Hornsea Project Four

Clarification Note on Underwater Noise Abatement Systems

Document Reference: G2.14

Noise Abatement Systems (NAS) Note

Figure 1 Wave rose for Site L1 – taken from Volume A5, Annex 1.1: Marine Processes Technical Report (APP-067).

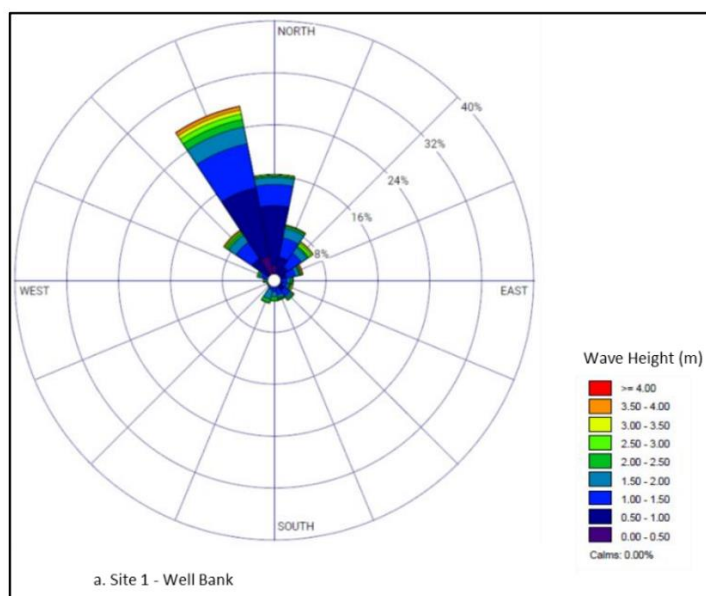
Section 4.1.3.9: *We request that the Applicant provide more information on the likelihood of NAS being suitable for the Hornsea 4 project. Several factors are listed as affecting the suitability of NAS, however these are factors that we would anticipate to be mostly already understood about the site, or possible to make generalisations on based on existing data. We wish to understand the likelihood of NAS being feasible as early as possible, given the Applicant's inclusion of this measure in both the OMMMP and the Outline SIP.*

Wave Height: Metocean data were available for site L1 Well Bank Flat (29 June 2010 to 4 July 2011). This site is around 5.4 km to the southeast of the southern boundary of the Hornsea Four array area. Significant wave heights at this site in this time period were typically less than 1.0 m but reached 4.5 m during a storm event in November 2011 (Figure 1) (Volume A5, Annex 1.1: Marine Processes Technical Report (APP-067)). A typical significant wave height of <1 m is below the reported wave height limitations for all NAS.
